Design Advice Request

DISCUSSION MEMO

Date: October 12, 2023
To: Portland Design Commission
From: Hillary Adam, Design & Historic Review Team
503-823-8953 | hillary.adam@portlandoregon.gov
Re: EA 23-075072 DA – Pepsi Blocks, Building B
Design Advice Request Memo – October 19, 2023

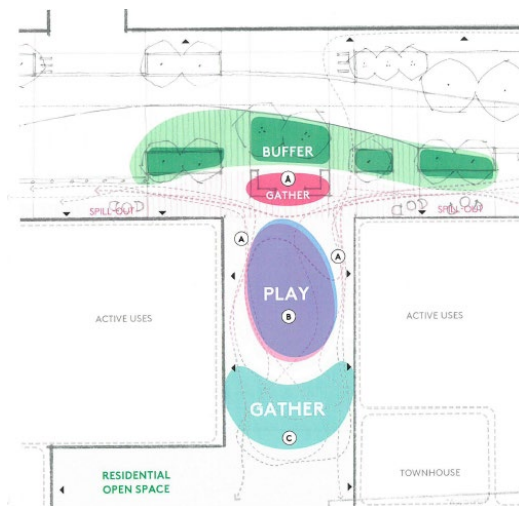
The proposed park design shows a general adherence to the 2018 parti diagram though it is not entirely clear if there is a gathering space at the north end (area A) with benches as is suggested by “g.i” above or if movable furnishings can be accommodated in area “C” as is suggested by “i.ii”. Staff notes that the parti diagram and the design framework for Pacific Park are a framework and not objective criteria.
